Doug's Opua Boatyard APP-039650-01-01

Discharges Boundaries

Project Title: Shellfish bed Sub-Surface Erosion Barrier

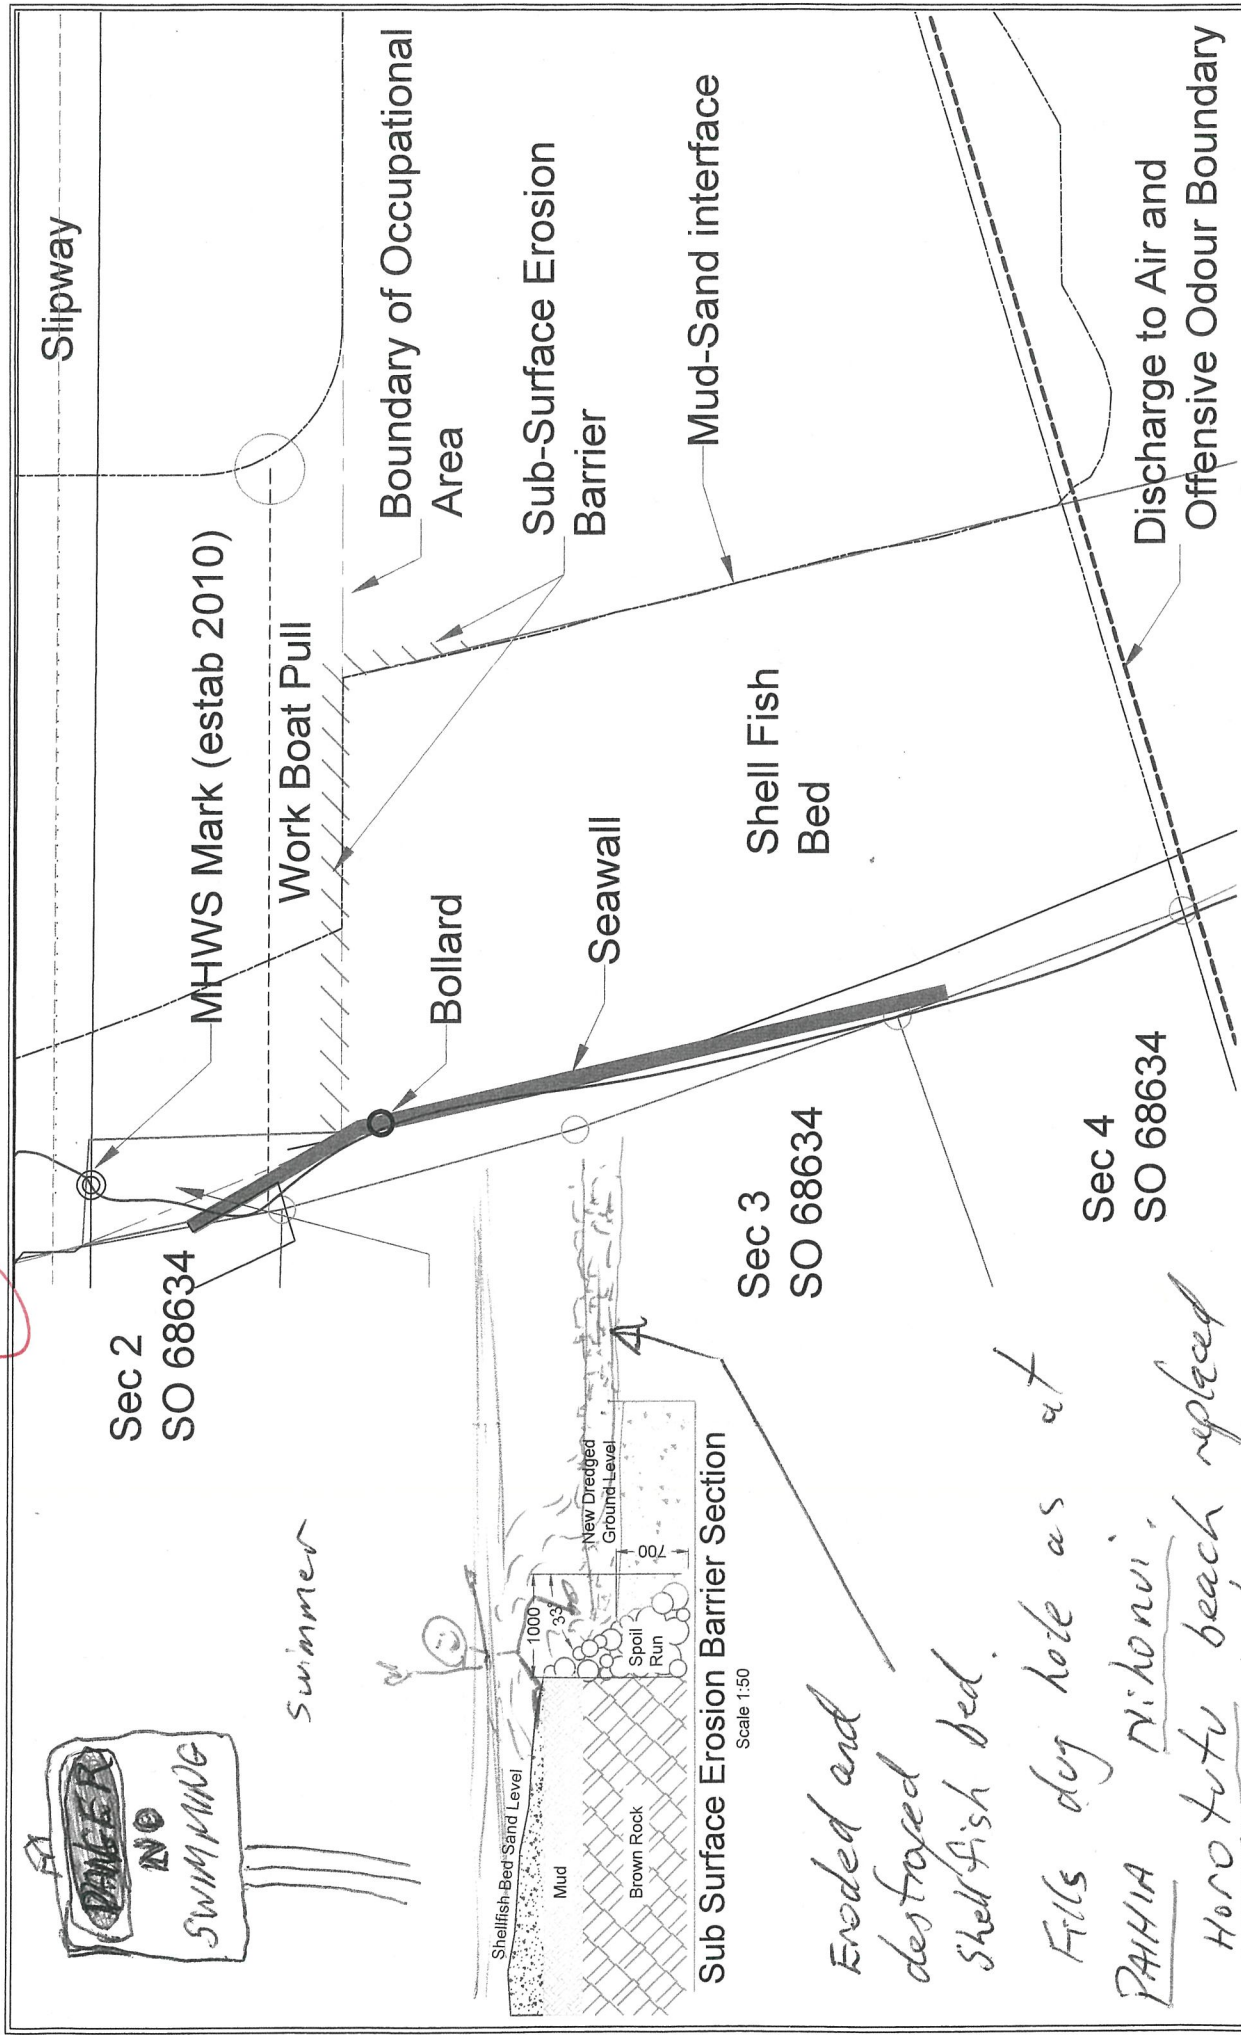
Eroded and destroyed shell fish bed.
Fills dry hole as at
PAHIA Nihonui.
Horotutu beach replaced by concrete.
